Bulletin

Application: Toyota A240L Series 1985-Up
Subject: Valve Body Gasket Revision

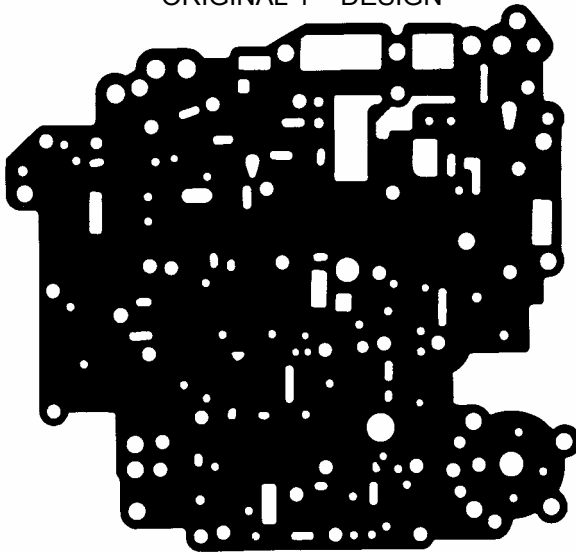
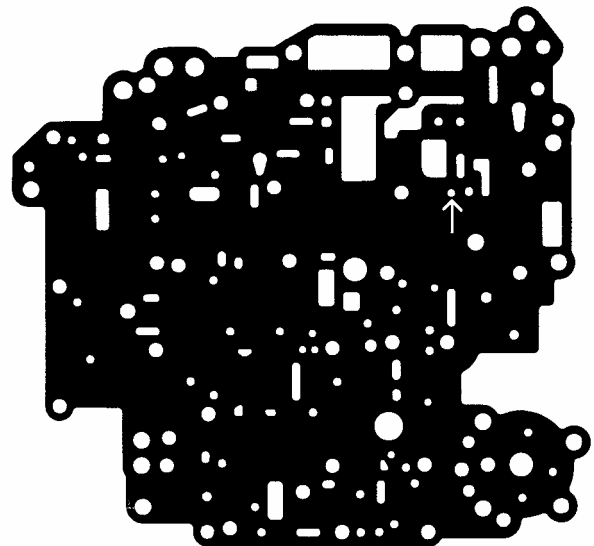
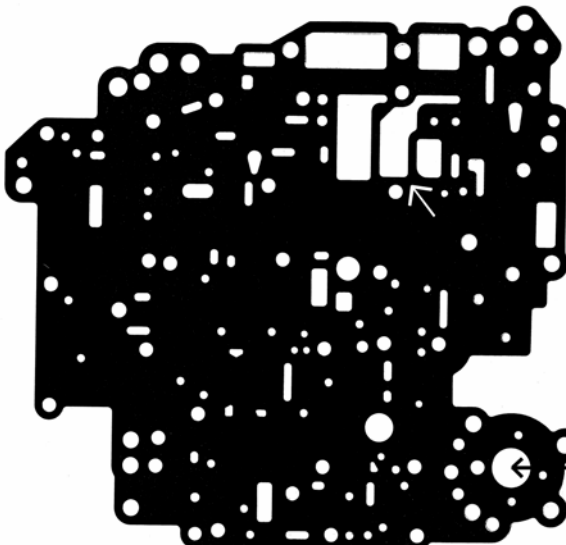
Toyota has made a second running change to the upper valve body gasket used on the A240L series units only. Please note that Toyota has kept the same OEM part number for this gasket, and that the latest design part will retrofit all previous models.

The following illustrations point out the changes made at each revision level. TransTec part #36192 is the current design level part and is included in all applicable TransTec gasket sets and overhaul kits with a date code of C04 and later.

Arrow shows added hole

Arrow shows design change in this area

Larger hole here
